Accesso ShoWare Scoreboard Replacement RFP – Addendum #1

UPPER LEVEL - EXISTING SCOREBOARD & PRODUCTION CONTROL ROOM
SCALE: 1/16" = 1' - 0"

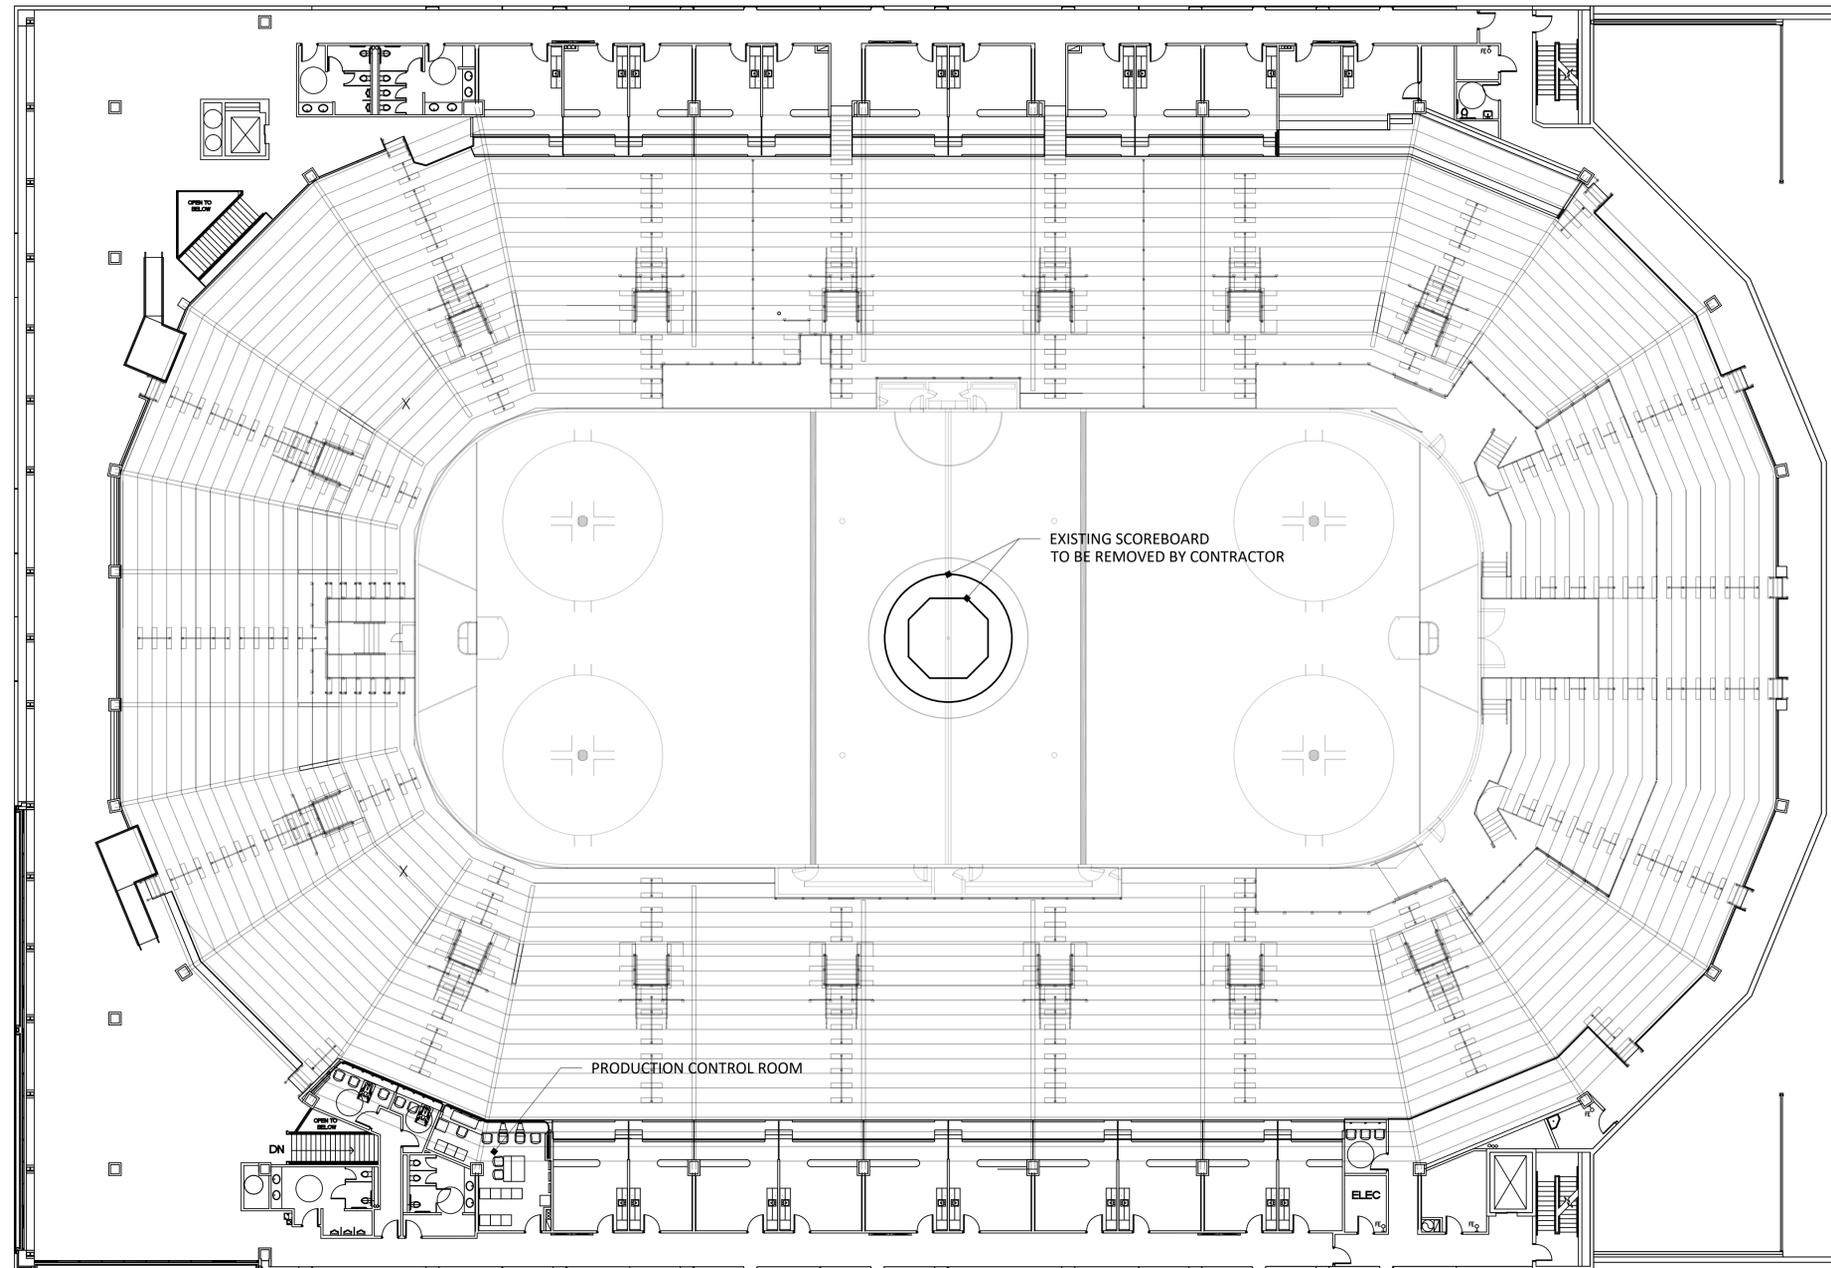
What is the distance between the CH Display and the VPCR

Refer to the drawings included in this Addendum, Exhibit A

CATWALK LEVEL - NEW LED SCOREBOARD
 SCALE: 1/16" = 1' - 0"

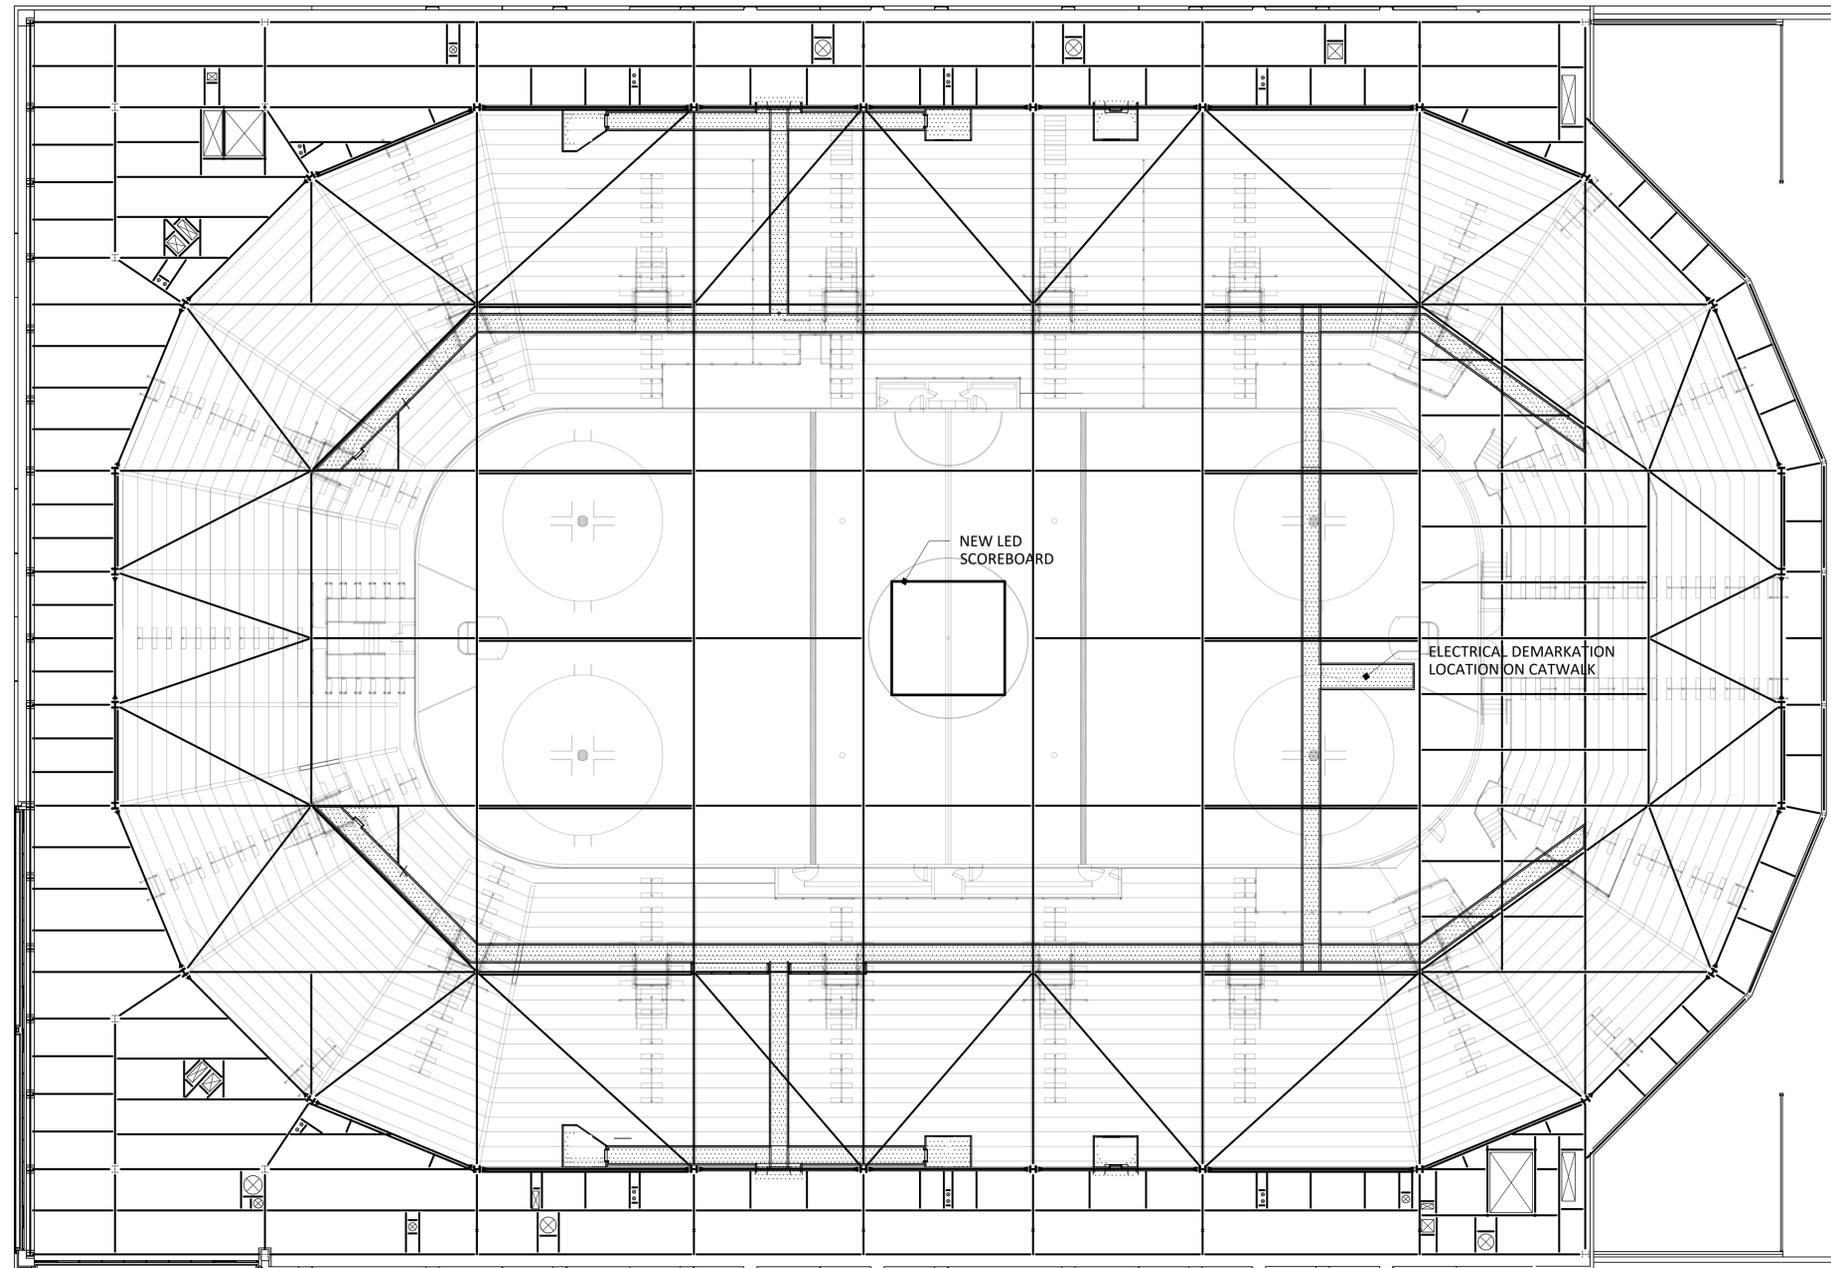
Are there more detailed versions of drawings LED 1 – LED 5 available?

Drawings are included in this Addendum, Exhibit A.

Weight Load of Concrete

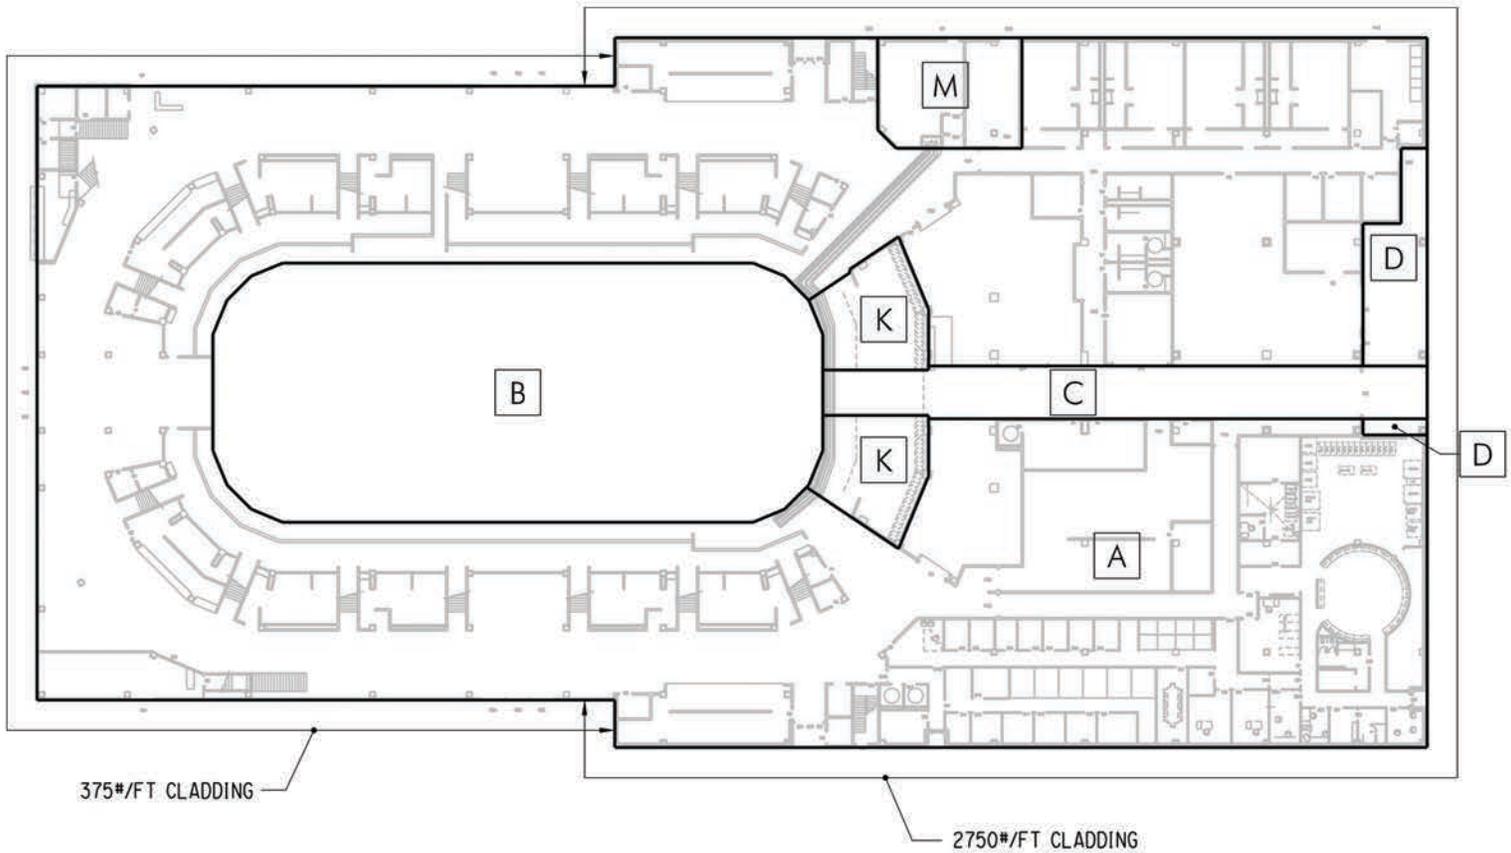
What type of equipment can we get into the arena?

Drawing is included with this addendum showing floor weight loads for equipment, Exhibit B & D.
